Staff Report

Mr. Paul Leong, Architect has applied for a Development Permit for 21 three-storey townhouse units on Heather Street in the McLennan South Area. The rezoning to CD/130 is expected to receive final reading on July 8 or July 22.

No. DP 01-195685

7340 HEATHER STREET TOWNHOUSE RICHMOND, BC.

1 5' Screen Timber Fence with Lattice Top
L-2 Scale: 3/4" = 1'-0"

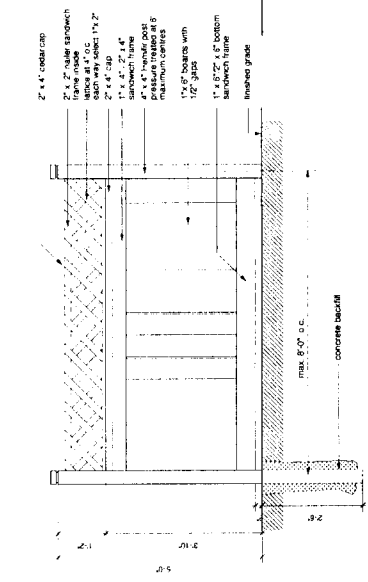
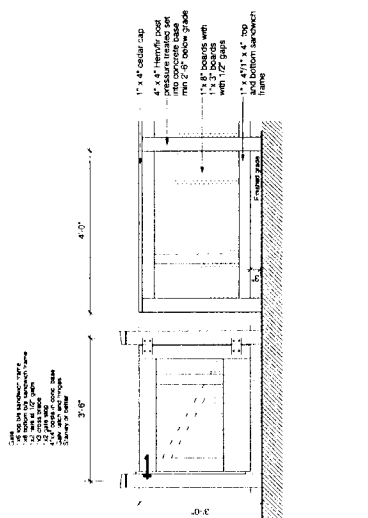
The proposed future development of the property to the south should be included in the context plan. In addition, the cross-access locations should be noted on the site plan. We would prefer that there be no 5 ft. fence at the property line.

- Setback and landscape between housing types/neighbourhoods. *The project complies.*
- Entry portals, etc. for transition...No vehicle gates. *The project complies.*
- Edges between properties to be semi-private but open (no high fences). *The perimeter fences should not be higher than 1.2 m.*
